Wisconsin Electric POWER COMPANY
231 W. MICHIGAN, P.O. BOX 2046, MILWAUKEE, WI 53201

June 20, 1979

DOCKET NO. STN 50-502
ADDITIONAL INFORMATION -- ENVIRONMENTAL REPORT
HAVEN NUCLEAR PLANT

FIGURE 36-1
 SITE AREA SOIL TYPES
 WISCONSIN UTILITIES PROJECT
 HAVEN NUCLEAR PLANT

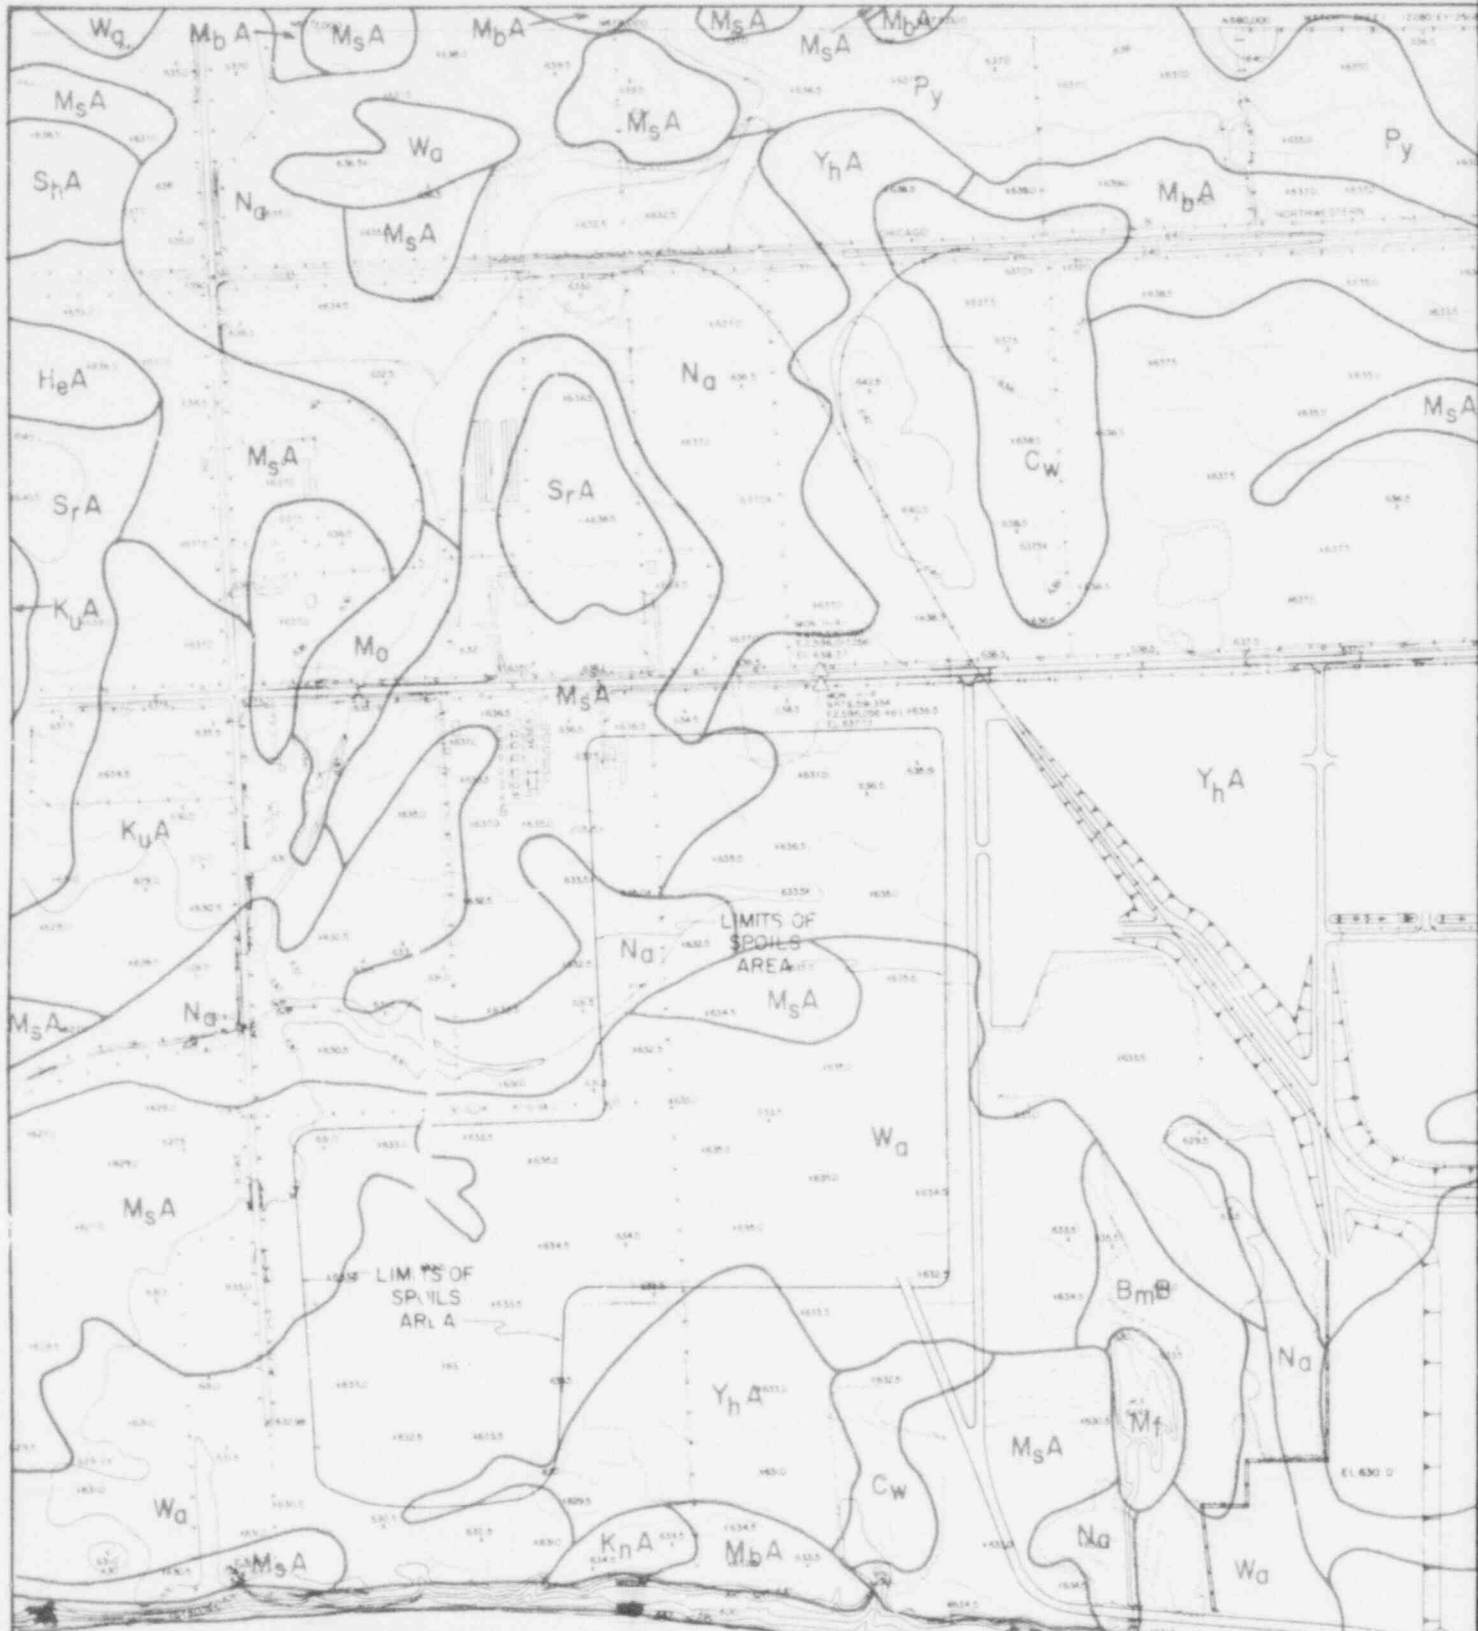
Provide a site map showing soil types accompanied by a description of the mapping units.

Figure 36-1 is a site map showing soil types, and Table 36-1 provides a description of the mapping units.
